Re: St. Lucie Plant Unit 2
Docket No. 50-389
Renewed Facility Operating License No. NPF-16

Response to NRC Request for Additional Information (RAI) Regarding Extended
Power Uprate License Amendment Request

**Response to NRC Nuclear Performance and Code Branch
Request for Additional Information**

SNPB-16

Figure-9
Large Break LOCA ECCS Performance for Limiting Seismic Loads Analysis
1.0DEG/PD Break
Peak Cladding Temperature

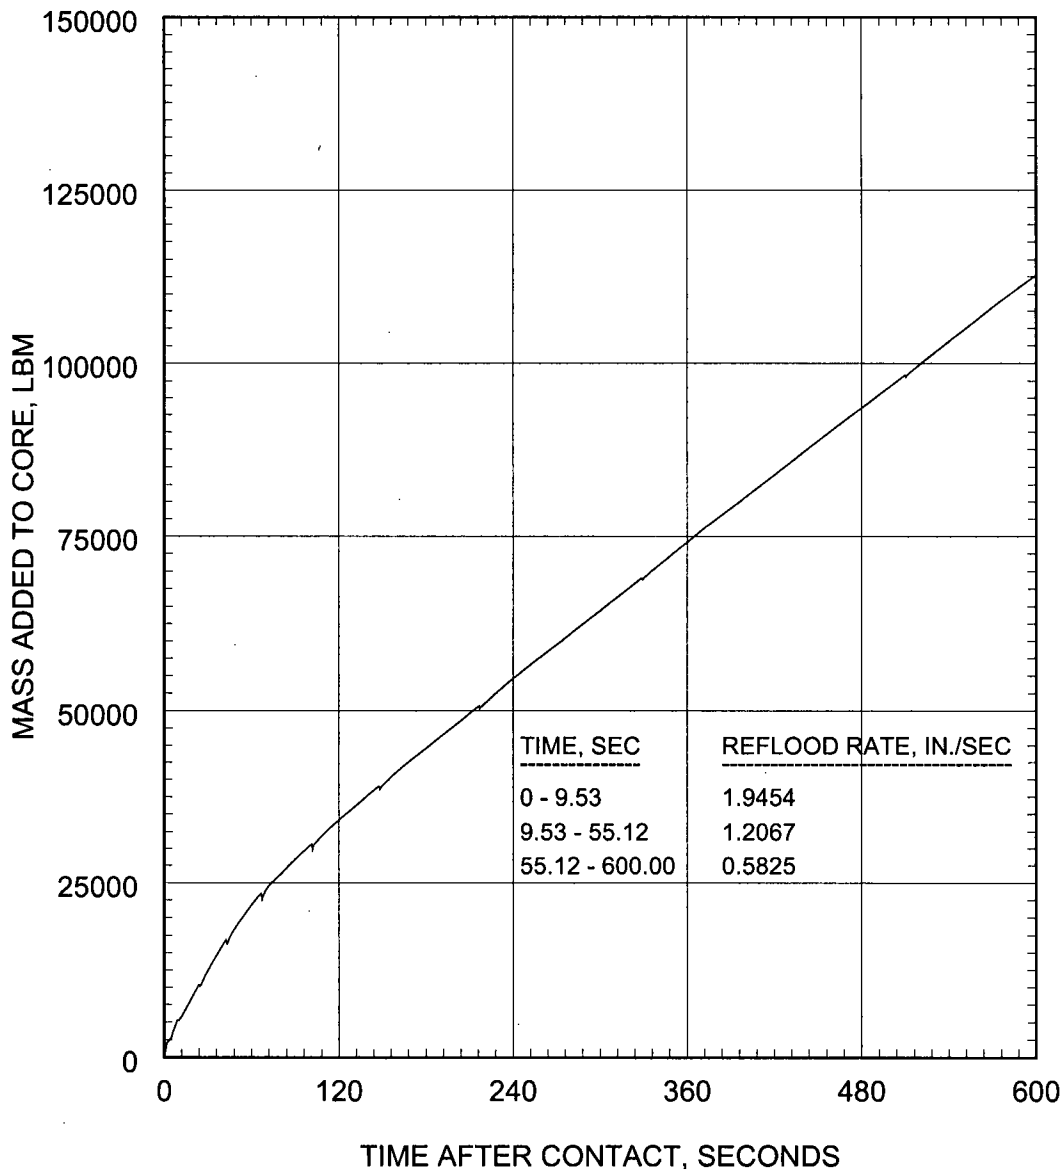
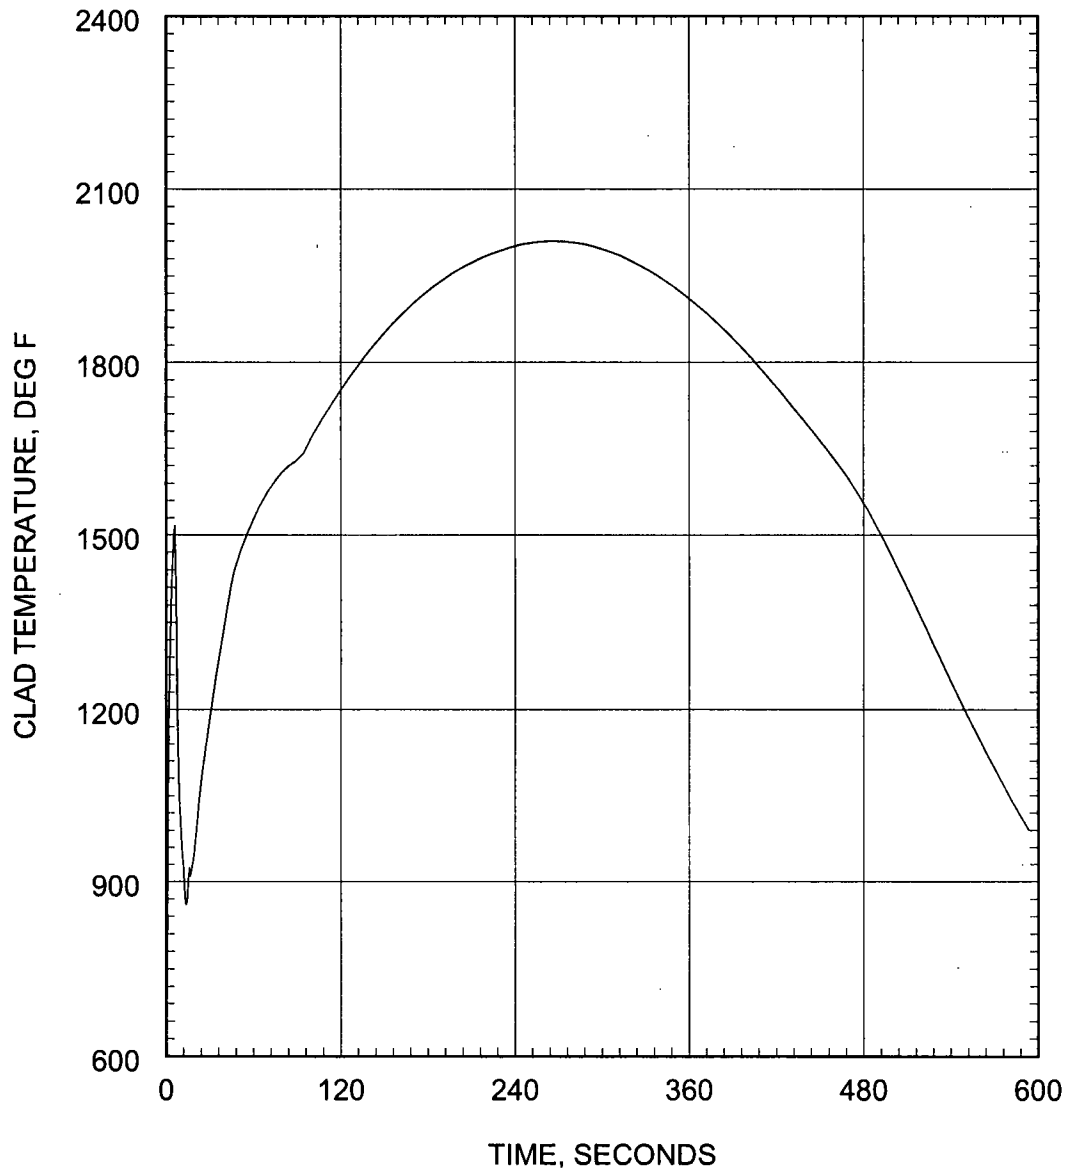
Please provide the results of the seismic LOCA loads analysis for the limiting break. Identify the maximum hot channel deformation/flow area reduction, the maximum hot bundle flow area reduction, the peak linear heat rate for the hottest rod in the assembly undergoing maximum deformation. Also, provide the linear heat rate for the bundle containing the rod with the max deformation. The analysis should provide the plots typical of the limiting large break LOCA analysis given in a chapter 15 analysis.

The variables listed in Table 2 are plotted as functions of time in Figures 1 through 9 for the 1.0 DEG/PD break, in Figures 10 through 18 for the 0.8 DEG/PD break, and in Figures 39 through 47 for the 0.4 DEG/PD break.
